HK2, Inc./SEMCO

July 21, 1998

Subject: Revised Work Plan for Preliminary Site Assessment at Scooter's Auto Repair,
3600 MacArthur Boulevard, Oakland, California (HK2 Project 97-0187)

SITE PLAN
 Scooter's Auto Repair
 3600 MacArthur Boulevard
 Oakland, California
Figure 2

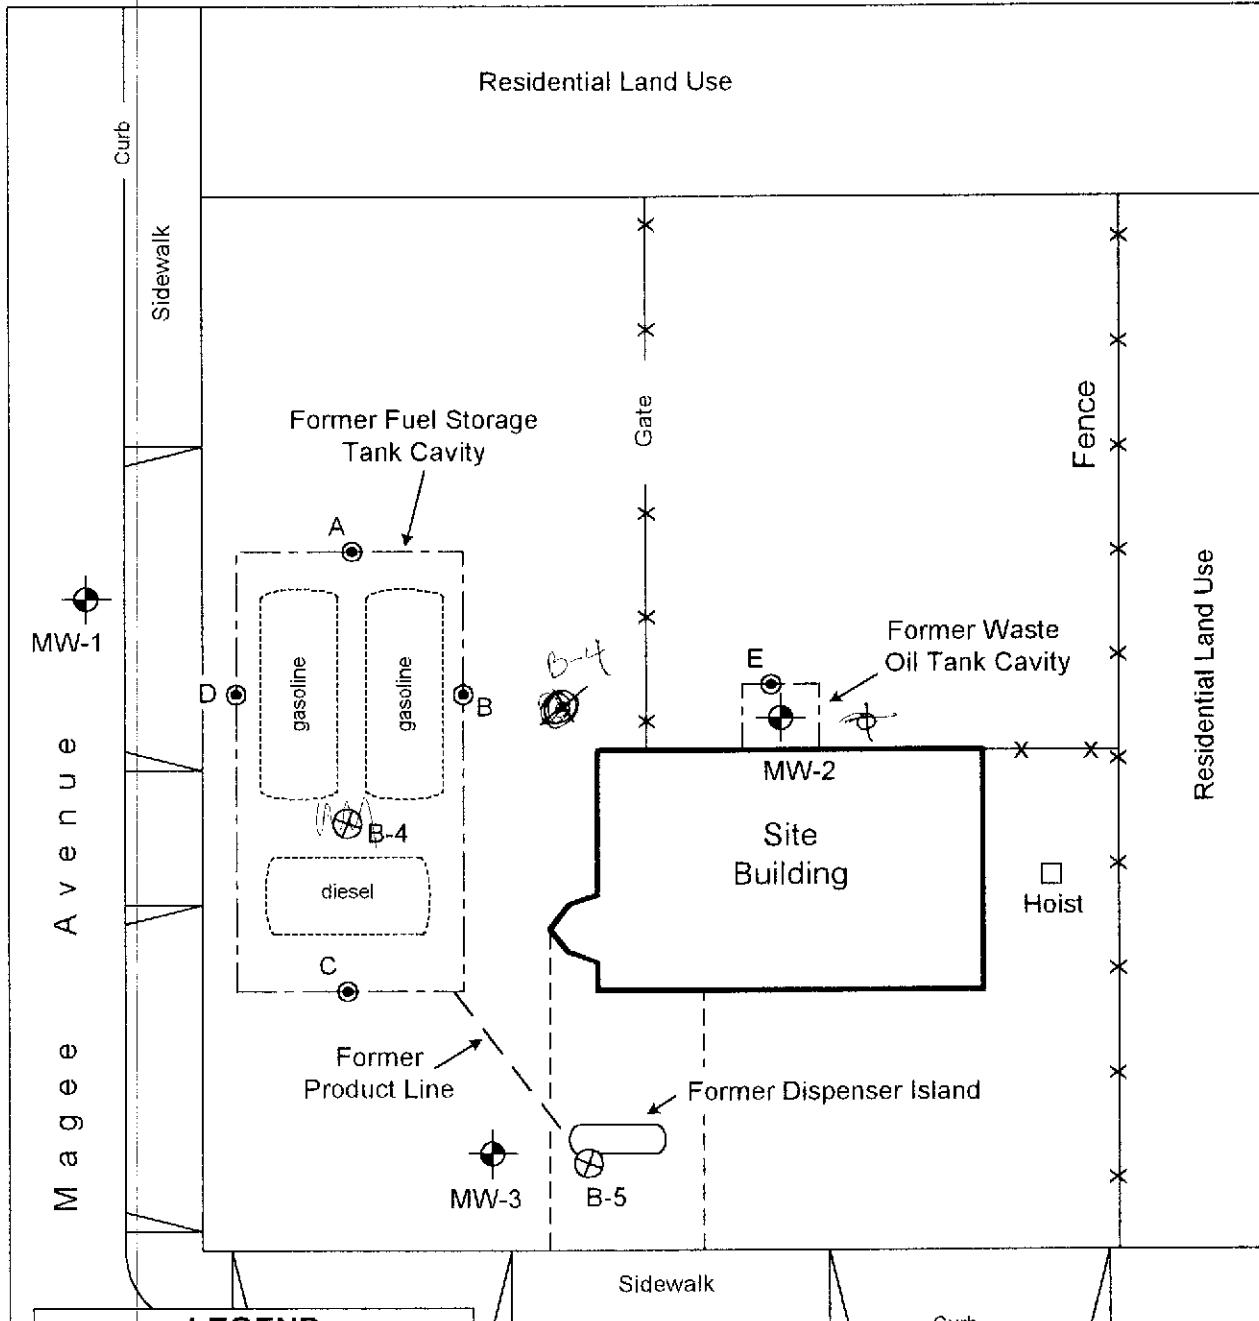
HK2 plans to drill five borings and convert three or four of the borings to groundwater monitoring wells to evaluate the lateral and vertical extent of hydrocarbons encountered during tank removal activities. The proposed location of the borings is shown in Figure 2. Borings B1 through B4 will be drilled up to approximately 45 fbg using a hollow-stem auger drilling rig. B5 will be drilled to approximately 6 fbg using a hand auger. The depth to groundwater is estimated at 33 fbg based on groundwater monitoring data collected approximately 600 feet west-southwest of the site (Exxon station at 3450 35th Avenue). *Site at 3580 MacArthur Blvd NW at 2.5 fbg to SW/SE*

Soil samples will be collected from B1 through B4 with a split-spoon sampler at approximately 5 and 7 fbg, every five feet thereafter, and at the capillary fringe and observed changes in lithology. A metal tube-lined slide-hammer will collect soil samples from B5 at approximately 3 and 6 fbg. The samples will be screened with an organic vapor meter (OVM), described using the Unified Soil Classification System, placed in an ice chest chilled to approximately 4°C, and submitted to a state-certified laboratory. Up to three soil samples from each deeper boring and two from B5 will be analyzed for TPH-G (EPA Method 5030/Modified EPA Method 8015), TPH-D and TPH as motor oil (TPH-MO; EPA Method 3550/Modified EPA Method 8015), benzene, toluene, ethylbenzene, and total xylenes (BTEX; EPA Method 8020), and methyl tert-butyl ether (MTBE; EPA Method 8020). In addition, the soil sample containing the highest TPH-D/MO concentration will be analyzed for polycyclic aromatic hydrocarbons (PAHs; EPA Method 8270) if the TPH-D/MO concentration exceeds 1,000 mg/kg, and one sample representative of the lithology of the vadose zone and upper saturated zone (a total of two samples) will be analyzed for bulk density, porosity, moisture content, fraction organic carbon, and grain size distribution. *↓ this should be from a clean boring*

can do silica gel cleanup.
